NOTICE OF CHANGE

MIL-STD-1835B
NOTICE 2
15 December 1997

INTERFACE STANDARD FOR
MICROCIRCUIT CASE OUTLINES

FIGURE 24. Ceramic, quad leaded chip carrier style with non-conductive tie bar - Continued.

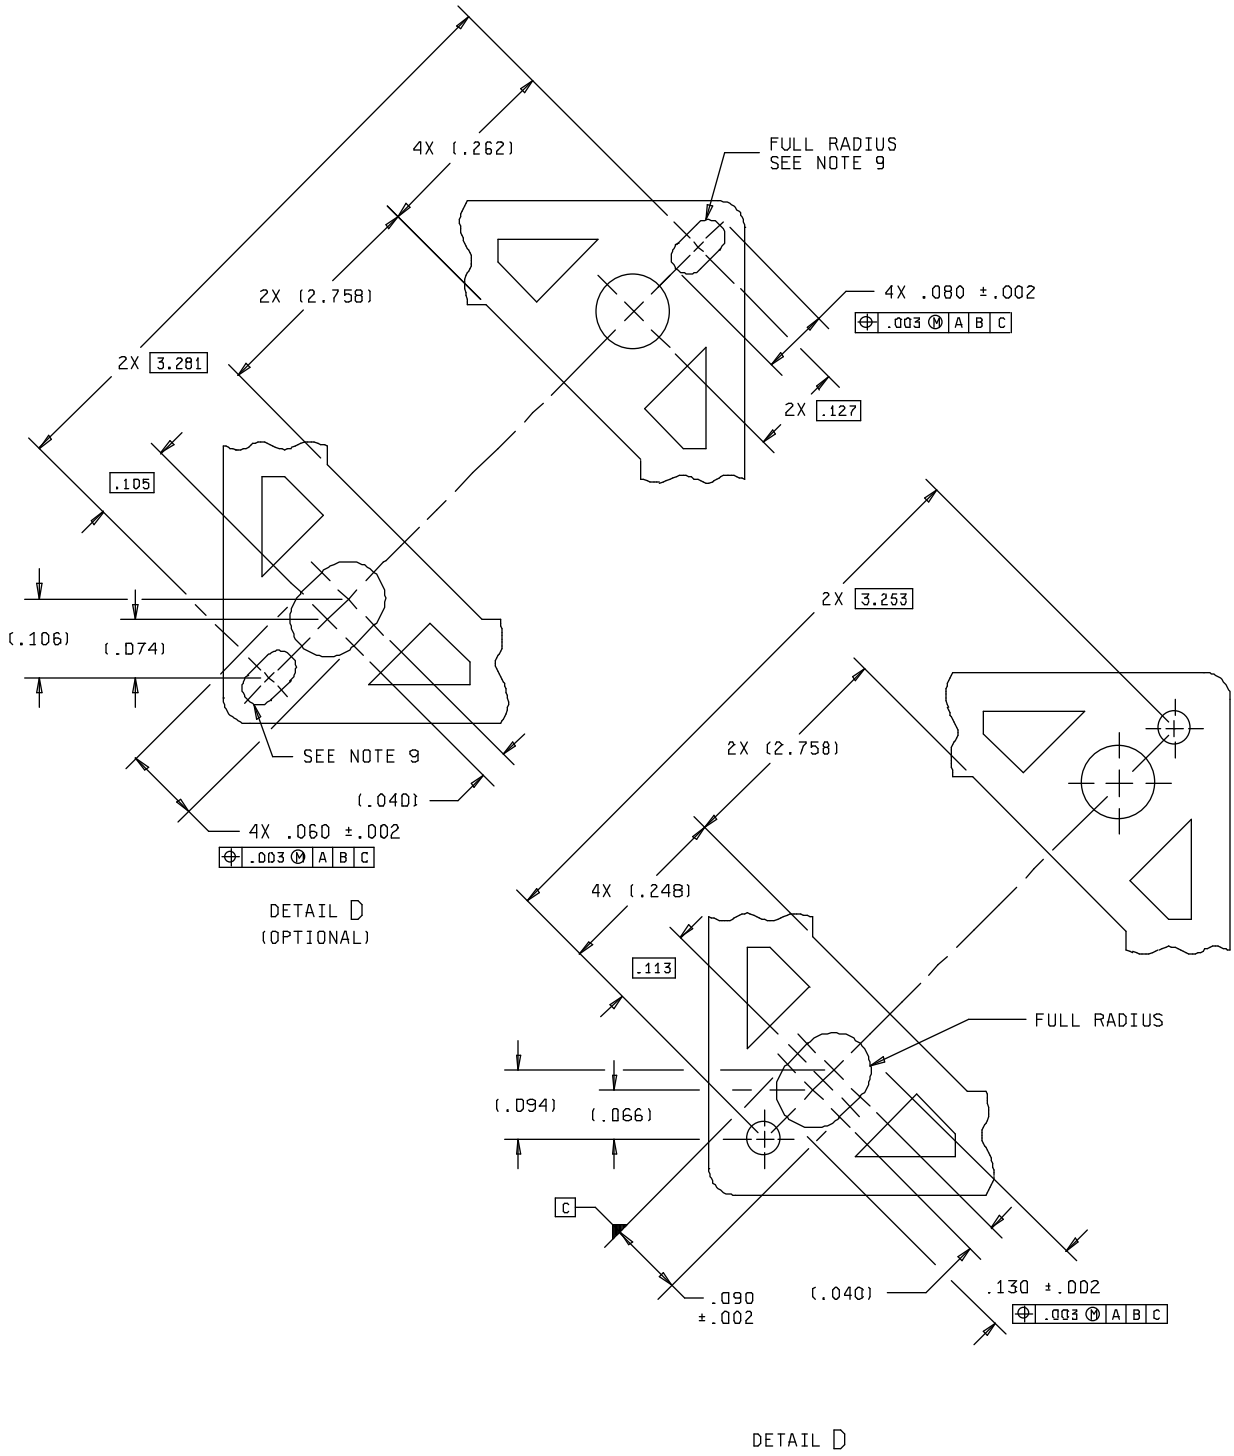
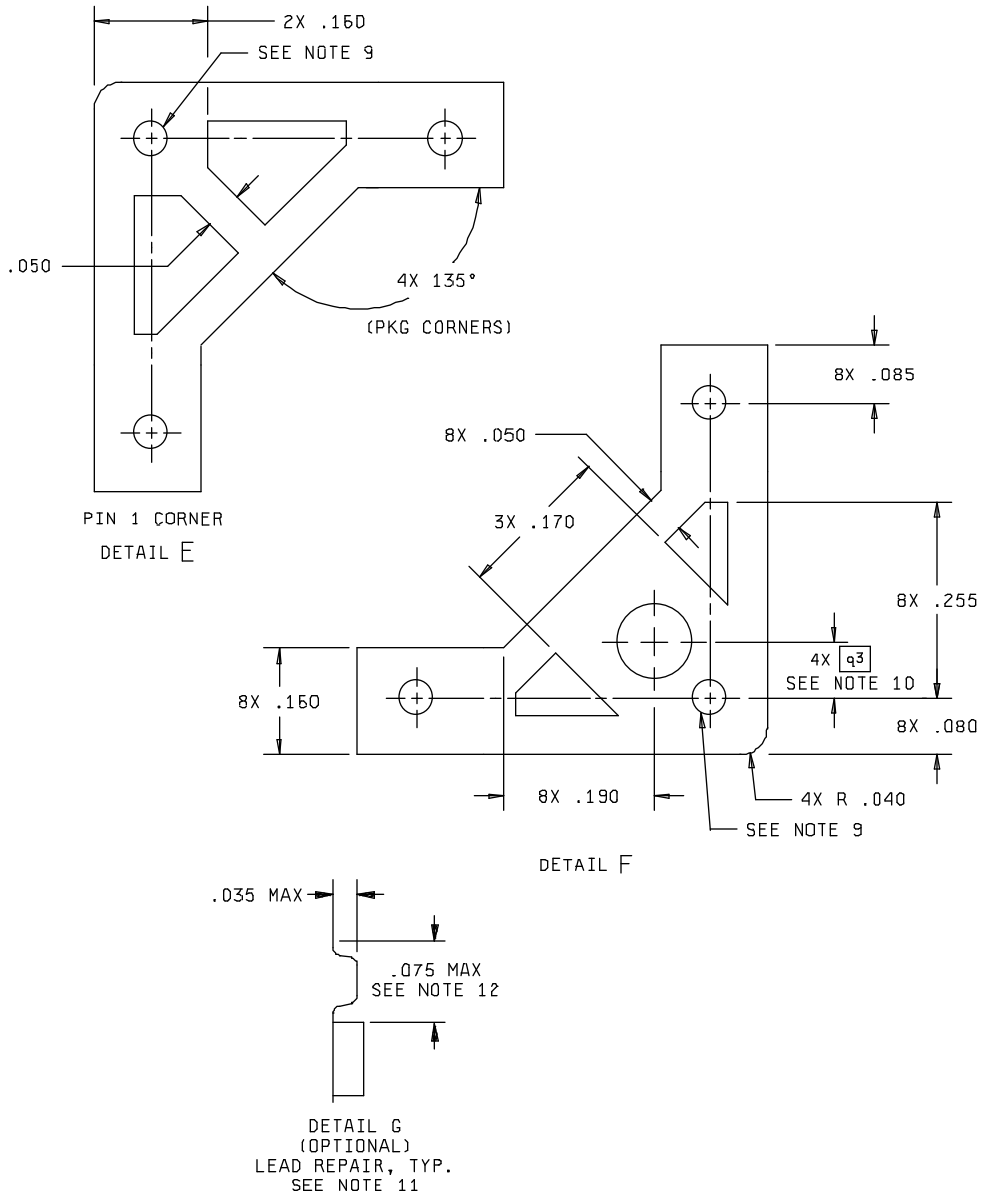
* 11. Lead repair is optional. This view shows the drawn portion of the lead that must reside within these dimensions. The shape of the repaired lead (as shown) is for reference only.

* 12. Coplanarity requirements do not apply in this area of a repaired lead.
